Project	IEEE 802.16 Broadband Wireless Access Working Group <http://ieee802.org/16>	
Title	Corrections for UL channel Sounding	
Date Submitted	2006-07-04	
Source(s)	Benny Getz, <i>Intel</i> , Mark Cudak, <i>Motorola</i> , <i>Samsung</i> , <i>Arraycomm</i> , <i>Beceem</i> , <i>Alcatel</i> , <i>Fujitsu</i>	benny.getz@intel.com mark.cudak@motorola.com
Re:	IEEE P802.16e-2005 and IEEE P802.16-2004 In response to call for maintenance change request (IEEE 802.16maint-06/018) issued on 2006-06-16.	
Abstract	Corrections and clarifications to UL channel sounding.	
Purpose	Adopt changes.	
Notice	This document has been prepared to assist IEEE 802.16. It is offered as a basis for discussion and is not binding on the contributing individual(s) or organization(s). The material in this document is subject to change in form and content after further study. The contributor(s) reserve(s) the right to add, amend or withdraw material contained herein.

Corrections For UL Channel Sounding

Intel, Motorola, Samsung, Arraycomm, Beceem, Alcatel, Fujitsu

Figure 1 - PAPR comparison between the existing corrupted sequence (existing) and the correct Golay sequence (fixed). Note that this graph does not reflect effects of rotation.

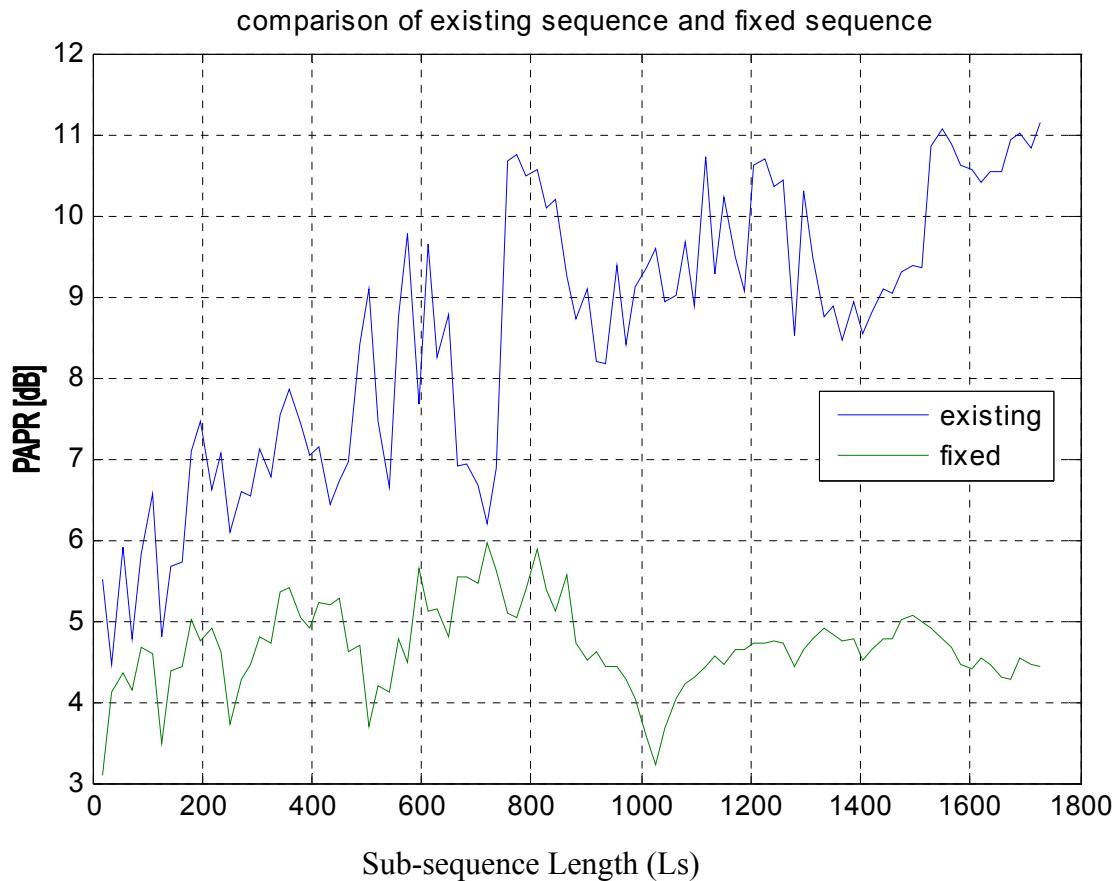
Existing Golay sequence in 802.16e-2005 has been corrupted when converted from binary to hexadecimal sequence. The sequence should be corrected to a true Golay sequence which can enable the low PAPR as originally intended. The existing sequence has high PAPR of up to 11dB compared to 5-6dB PAPR achievable with the original sequence.

See Figure 1 for PAPR comparison between the existing corrupted sequence and the correct Golay sequence.

Figure 2 – CDF of PAPR for various **cyclic shift allocation lengths**
over all possible inter-cell variation values

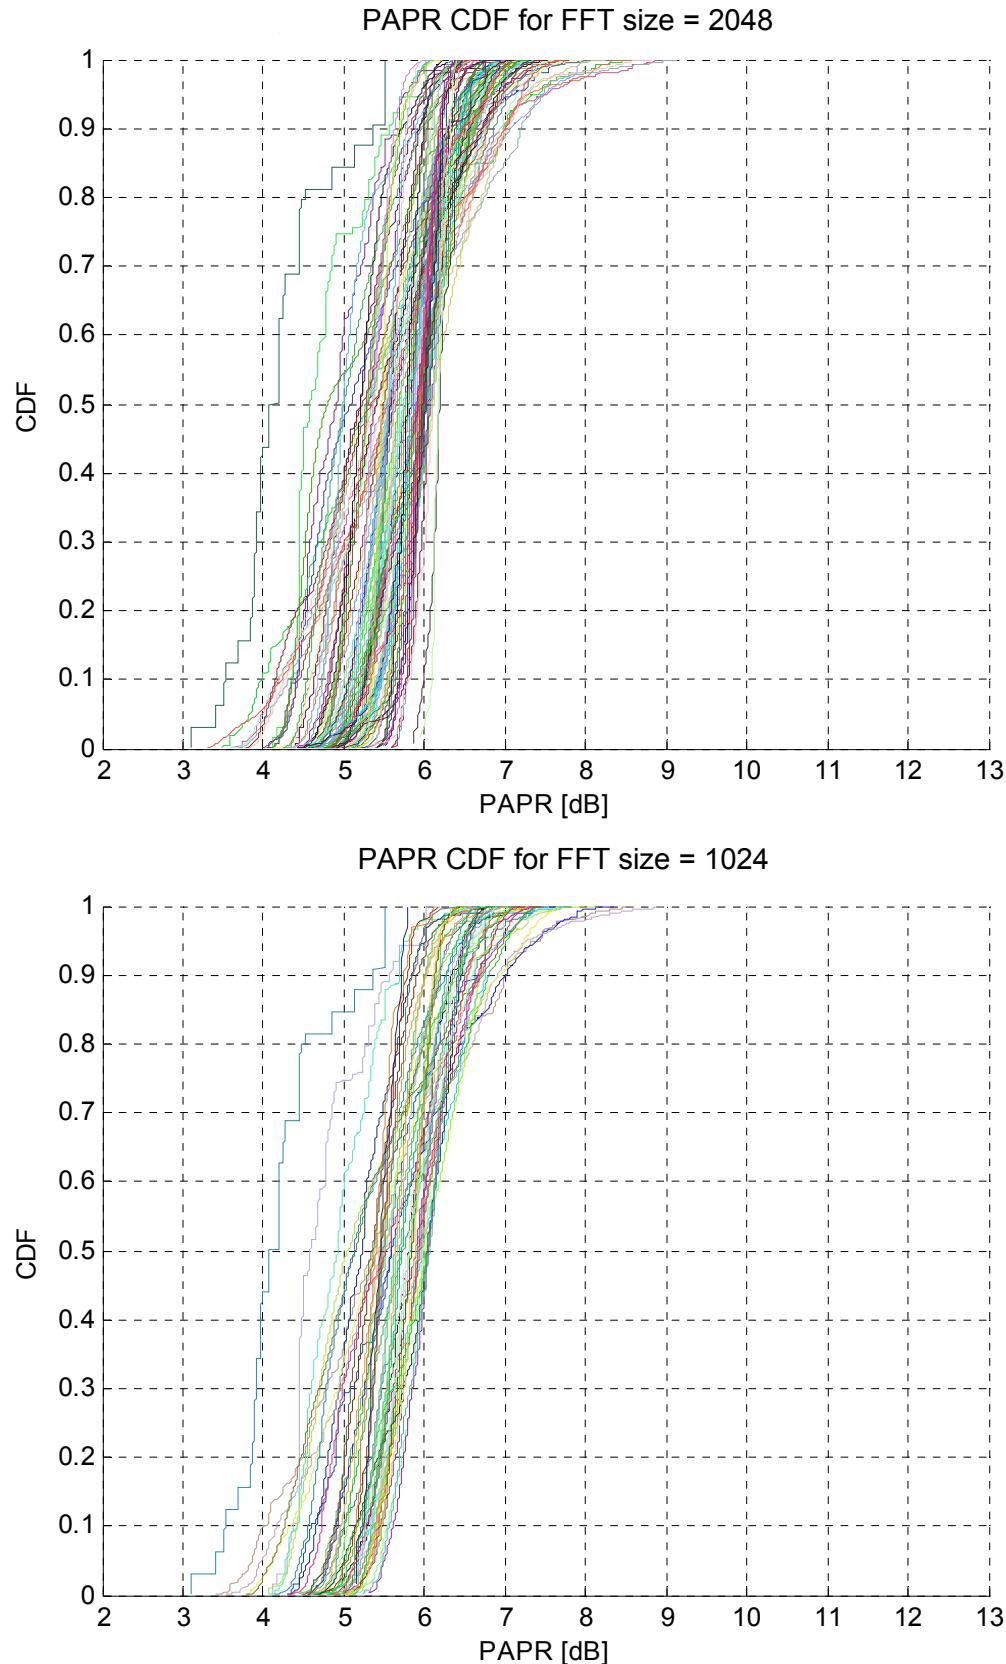
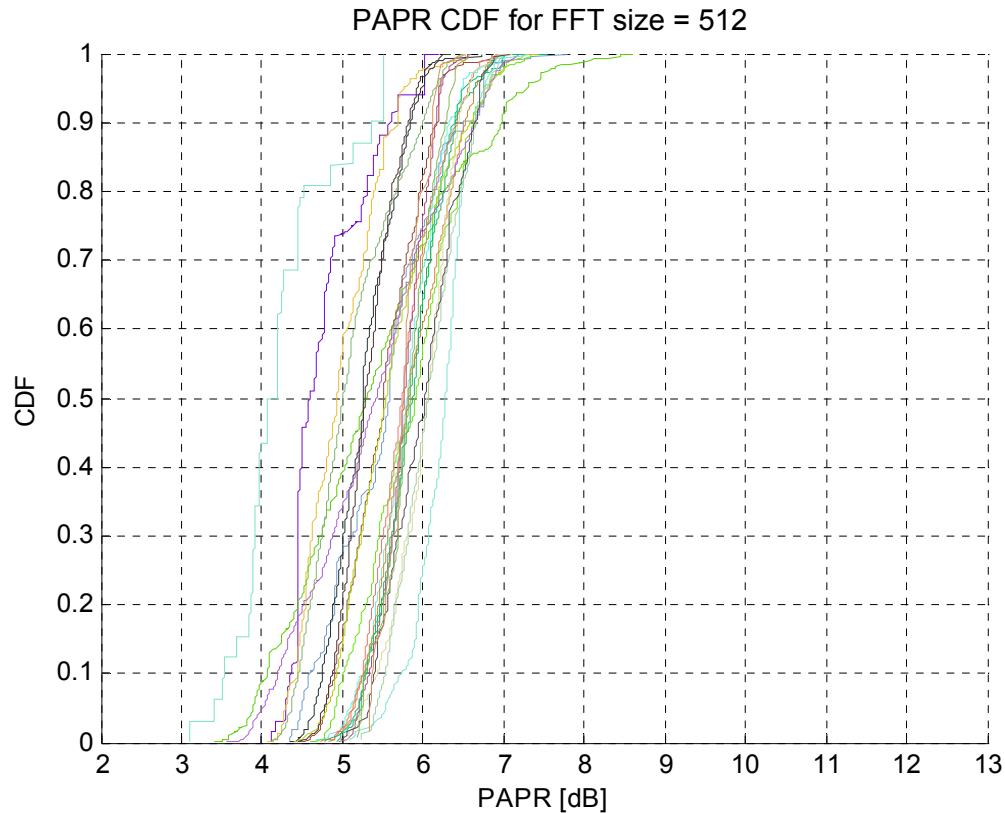
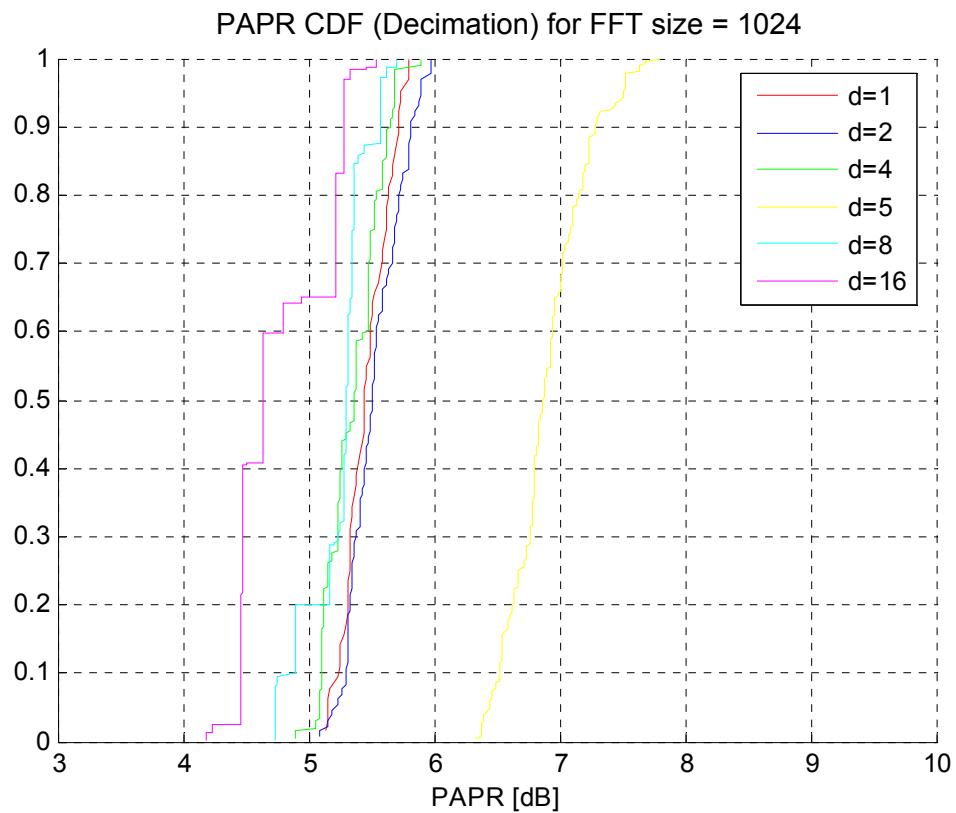
When the allocated sub-carriers/bands of the sounding signal contain the DC tone it is important to prevent discontinuity of the Golay sequence which increases the PAPR by approximately 2 dB.

Therefore it is required to puncture the Golay sequence at the DC tone (i.e. skip over the sequence value that would have been assigned to the DC tone).

In a similar manner it is important to prevent discontinuity of the decimation interval when crossing the DC, therefore the DC tone should be counted in the calculation of the decimation, and if the decimation offset selected leads to selection of the DC tone as one of the active tones it should be punctured as well resulting in almost double the decimation interval without a transmitted tone.
